July 20, 2015

**AMENDMENT NO. 3**

VA Health Care System  
Remodel and Expand Urgent Care  
Fargo, ND      Image 1205.13 / VAHCS 437-312

## FIRST FLOOR VENTILATION PLAN

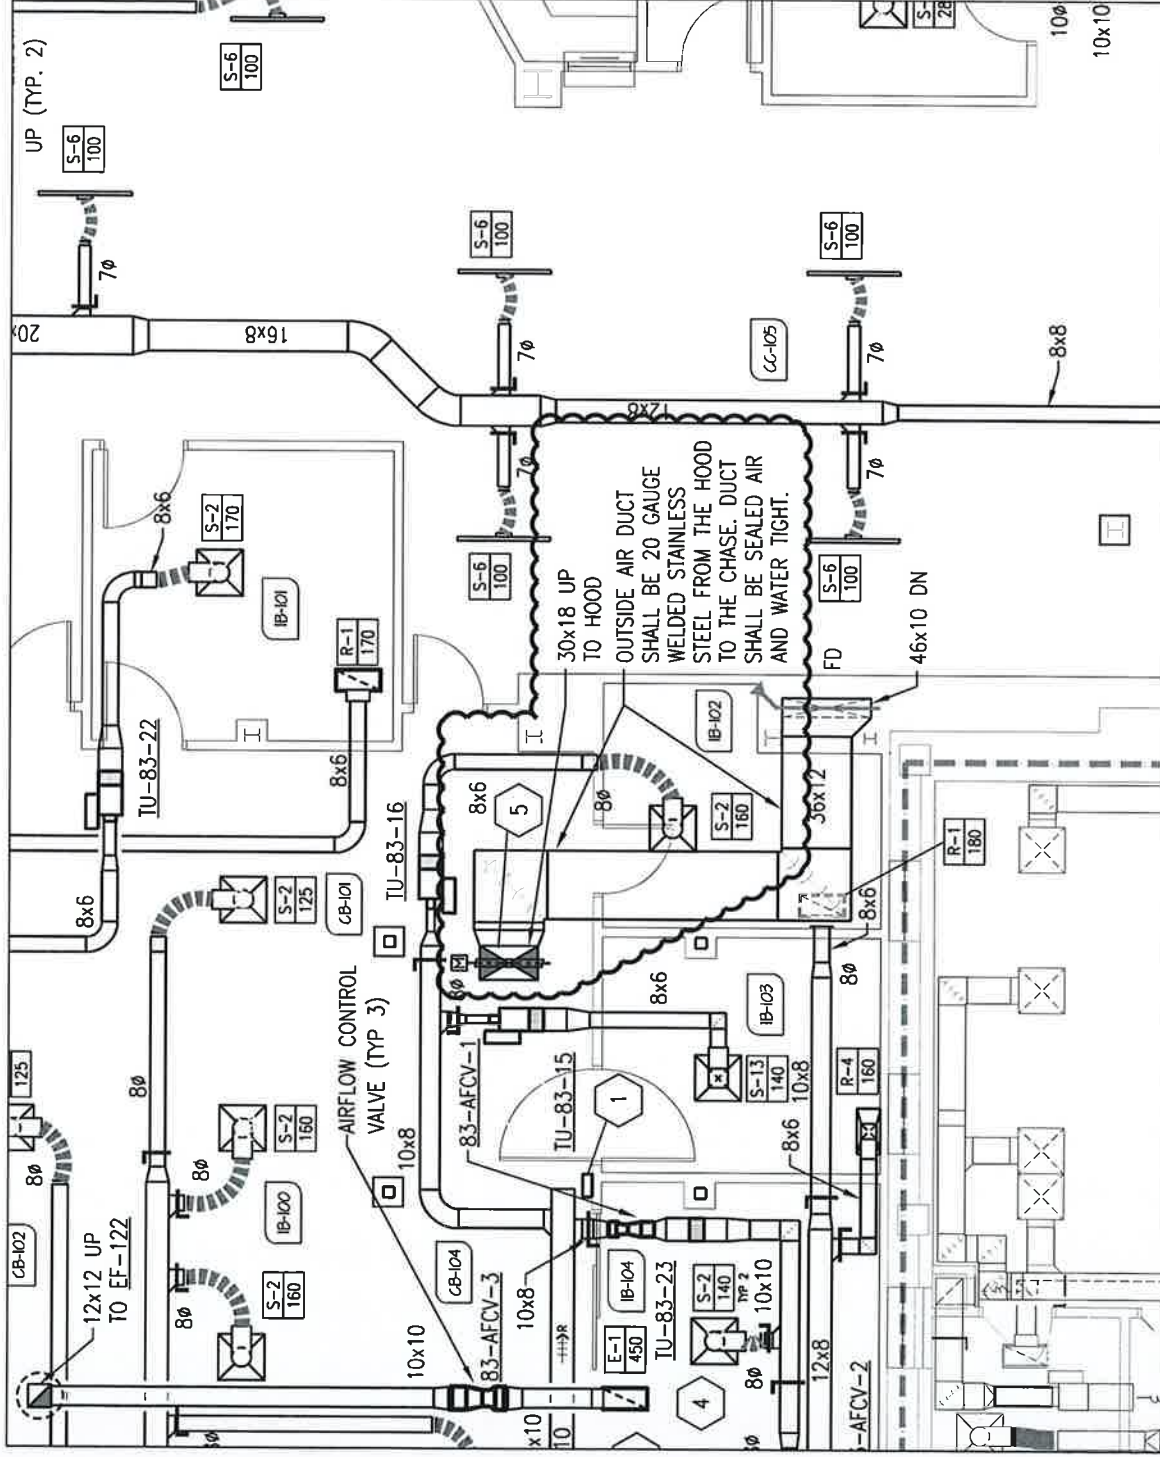
- 11. Refer to Drawing Sheet H9 FIRST FLOOR VENTILATION PLAN:
  - a. The outside air ducts serving Hoods RH-1 and RH-2 shall be moved to the roof. See attached plan for more information.

- b. The ductwork serving Hood RH-3 shall be changed to welded stainless steel as noted on the attached plan.
- 12. Refer to Drawing Sheet H10 ROOF VENTILATION PLAN:

### ROOF VENTILATION PLAN

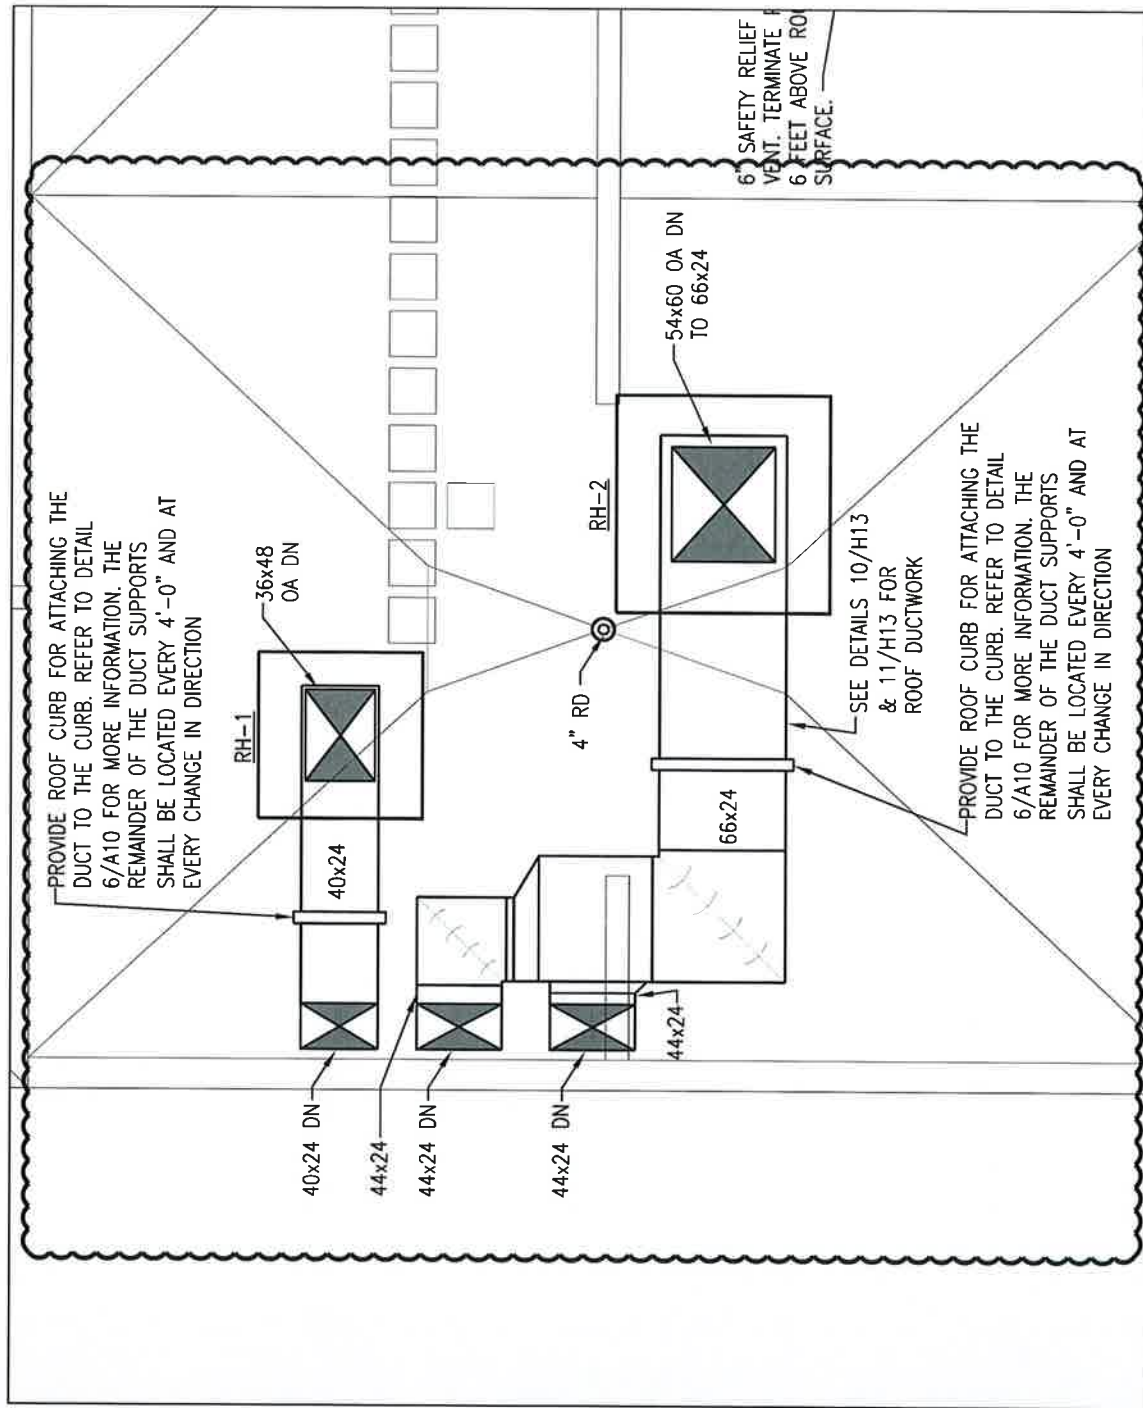
- a. The outside air ducts serving Hoods RH-1 and RH-2 shall be moved to the roof. See attached plan for more information. Curbs for the roof hoods will not be required, but curbs for the duct penetrations through the roof will be required. Coordinate location of the pre-fabricated roof curbs at duct roof penetrations.

- b. Roof duct supports shall be equal to PHP Systems PPH-D channel strut supports. See attached plan for roof curb support locations.
  - c. All Hoods RH-1, RH-2, and RH-3 shall be finished with painted enamel coating with a color to be selected during shop drawing review. Provide color chart for selection.

**DUCTWORK DETAIL**

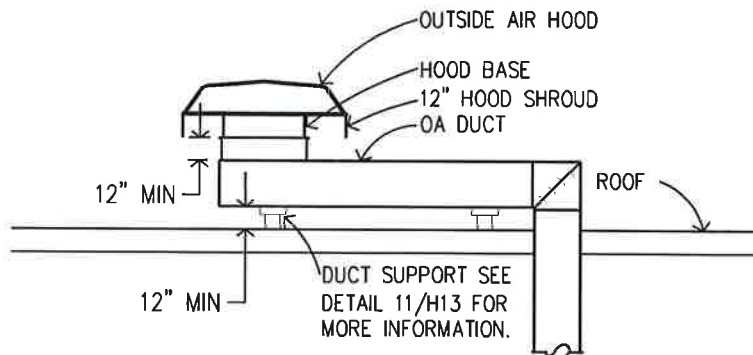
- 13. Refer to Drawing Sheet H13 MECHANICAL DETAILS AND SYMBOLS AND ABBREVIATIONS: See attached plans for added roof duct details. Insulation and coverings for exposed rooftop ductwork is not required.

**EXTERIOR  
DUCT INSTALLATION DETAIL**

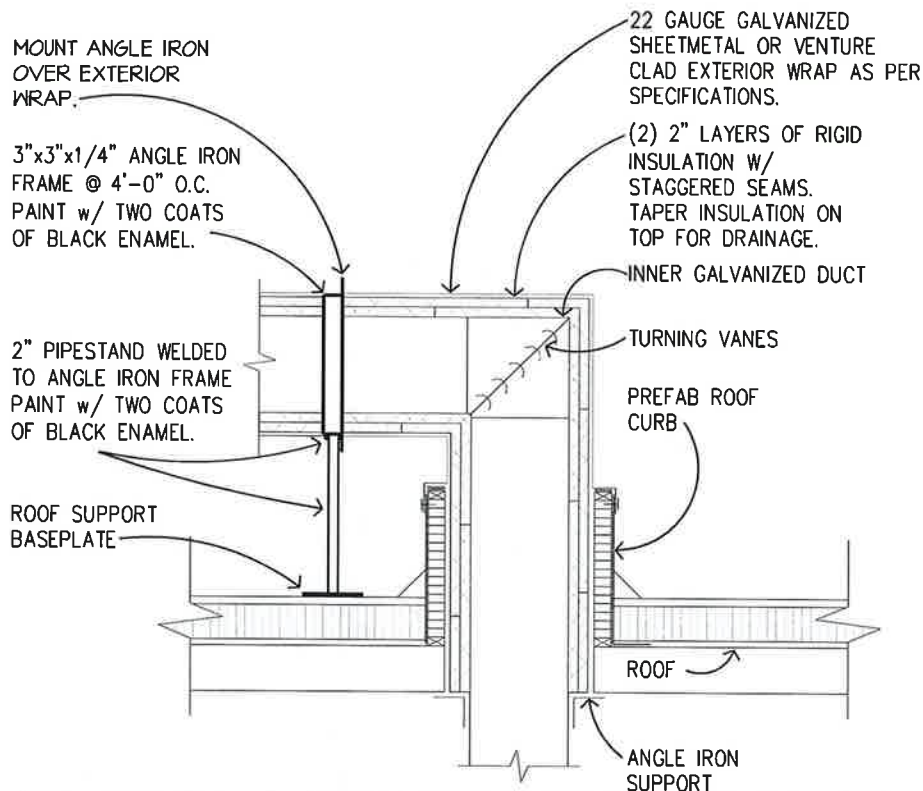
1. DUCT SHALL SLOPE TO ONE SIDE FOR RAIN REMOVAL.

## PARTIAL SITE PLAN - ELECTRICAL

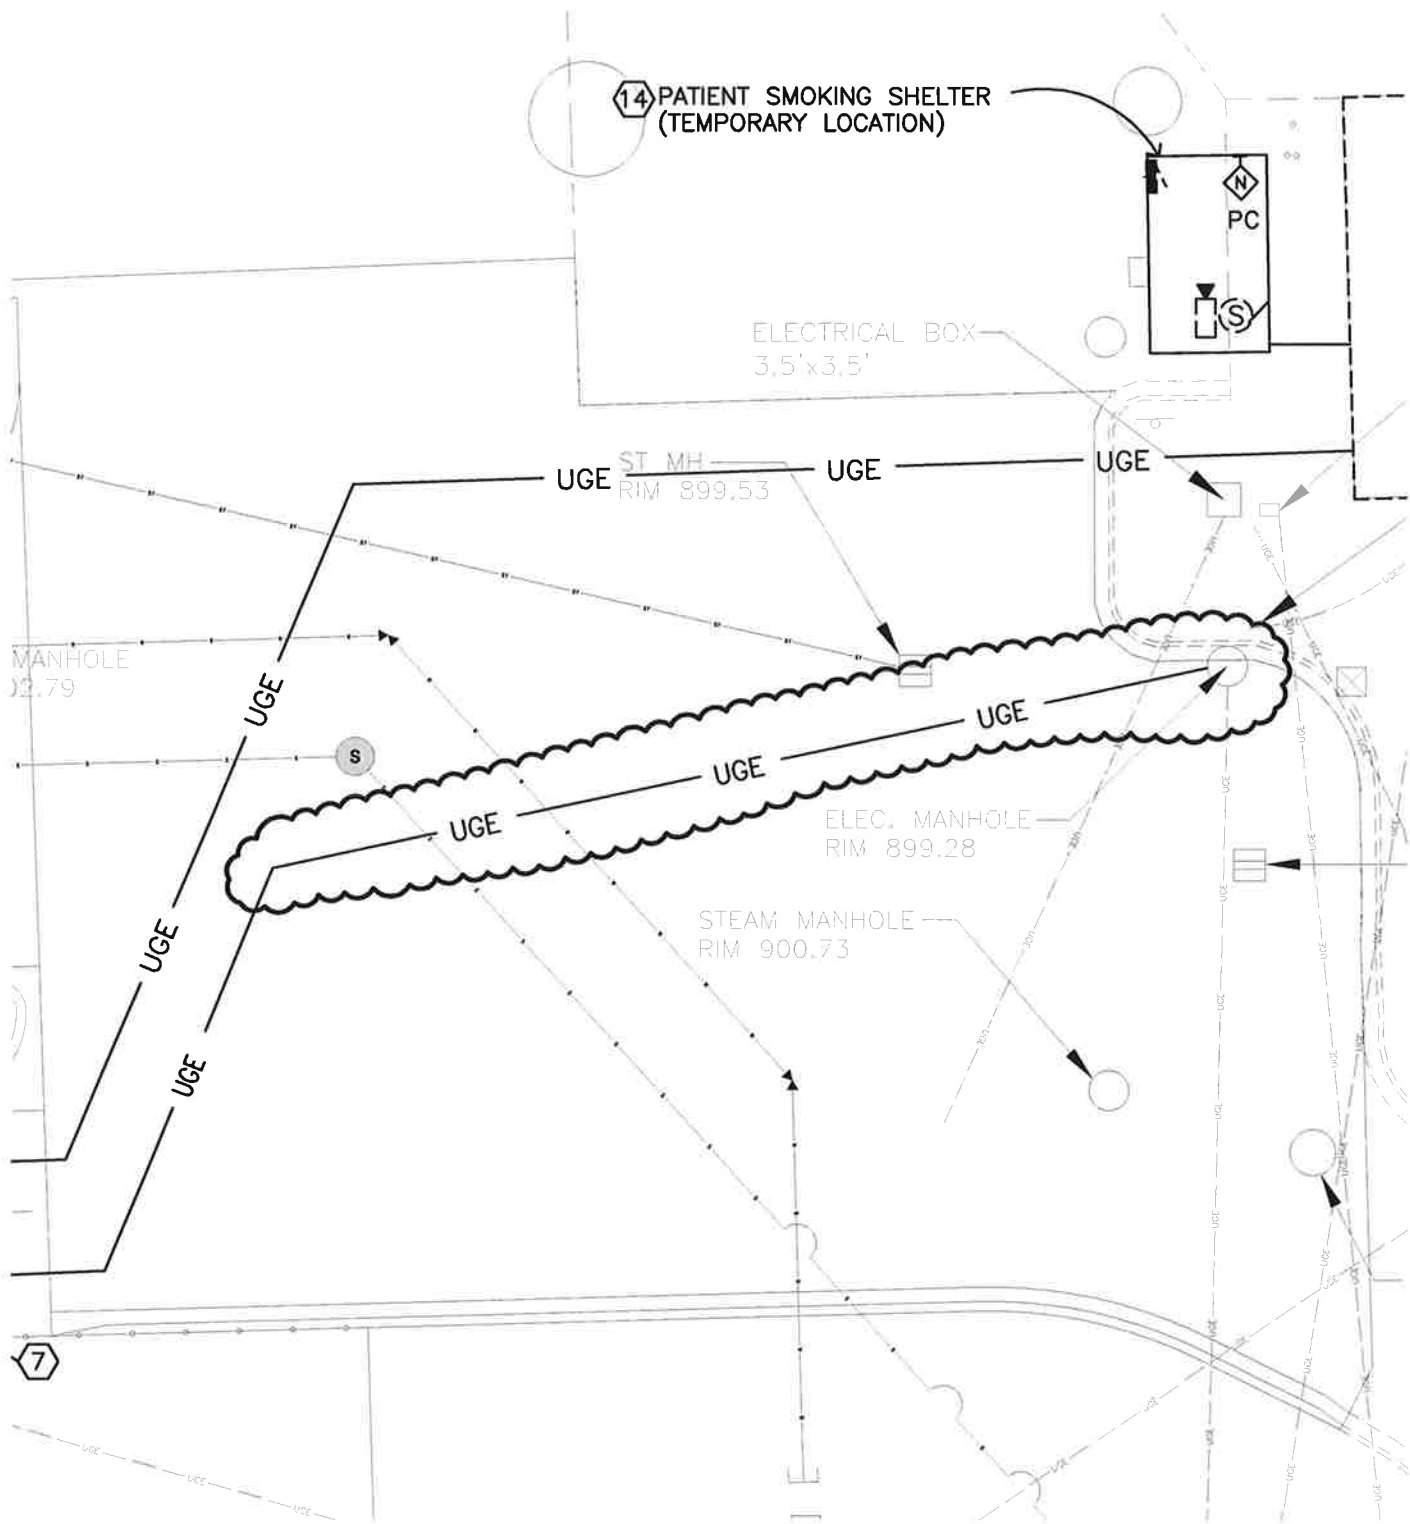
- 14. Refer to Drawing Sheet E2 SITE DEMOLITION PLAN - ELECTRICAL: OMIT all references to Building 2 demolition.
- 15. Refer to Drawing Sheet E3 SITE REMODELING PLAN - ELECTRICAL: REVISE rerouting of 5KV line to Building #11 manhole as indicated on attached Drawing E3/R1.
